Access Compliance Report

Public Rights-of-Way

(Curb Ramps)

Intersection ID: 51397	Main Street: WINDYRUSH_RD	Cross Street: BANFIELD_PL	Location: S
ADA ID: 14F0D757DB84	Ramp Type: PerpDiag	Initial Pass/Fail: Fail	Overall Compliance: No
Severity Score: 10			
Codes/Mitigation Info/Possible Solution		Field Measurements/Component Compliance

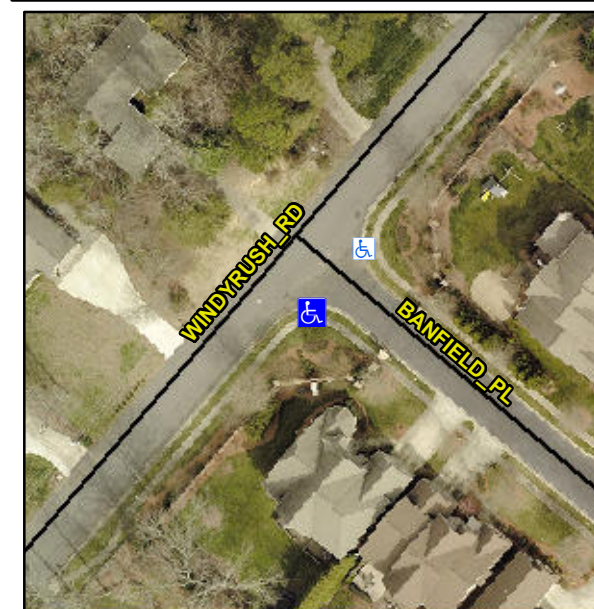
Not Found, R304.5.1, R304.5.3

Compliance	Description	Data	Compliance	Description	Data
N/A	Ramp Length (in)	46.0	Yes	Ramp Slope (%)	5.6
No	Ramp Width (in)	44.0	No	Ramp XSlope (%)	3.9
N/A	Flare Type LT	N/A	N/A	Flare Type RT	N/A
N/A	Flare Slope LT (%)	N/A	N/A	Flare Slope RT (%)	N/A
N/A	Flare Traversable LT?	N/A	N/A	Flare Traversable RT?	N/A
N/A	Landing Length (in)	N/A	N/A	DWS Provided?	N/A
N/A	Landing Width (in)	N/A	N/A	DWS Contrast?	N/A
N/A	Landing Slope (%)	N/A	N/A	DWS Length (in)	N/A
N/A	Landing X Slope (%)	N/A	N/A	DWS Full Width?	N/A
N/A	Landing Curb? (Y/N)	N/A	N/A	DWS Offset (in)	N/A
N/A	Shared Landing?	N/A			
N/A	Gutter Ponding?	N/A	N/A	Gutter Slope (%)	N/A
N/A	Gutter Lip Ht (in)	N/A	N/A	Gutter X Slope (%)	N/A
N/A	Painted X Walk1?	No	N/A	Painted X Walk2?	No
	X Walk 1 Direction	To NE		X Walk 2 Direction	To NW
N/A	X Walk 1 Width (in)	N/A	N/A	X Walk 2 Width (in)	N/A
	X Walk 1 Slope (%)	1.4		X Walk 2 Slope (%)	3.0
	X Walk 1 X Slope (%)	2.7		X Walk 2 X Slope (%)	1.8

Remove & Replace Curb Ramp With Two New Directional Ramps or Equivalent.
